INALWAYS ELECTRONICS INC.

產品變更通知 Product Change Notice

No. 20240717

Inalways P/N(華瑋/力瑋)料號: 0718-1-PQ-2BK/0718-1-PP-2BK/0718-1-PW-2BK/
0718-1-PN-2BK/0718-1-PN-A-2BK

Description(變更描述)

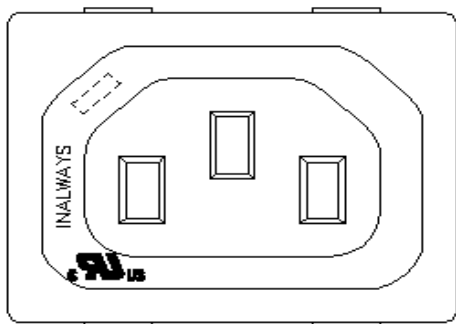
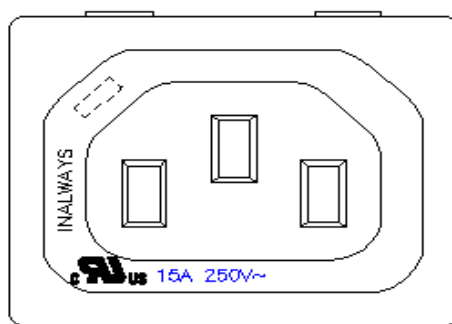
- UL 測試升級，由原來 10A 250V~ 升級為 15A 250V~。
UL test upgrade, from the original 10A 250V ~ upgrade to 15A 250V ~。
- 變更後的圖紙如附件
The drawings are as attached files.
- 變更刻字後的出貨將於 2024/10/01
The marking changes shipment will be started from 2024/10/01
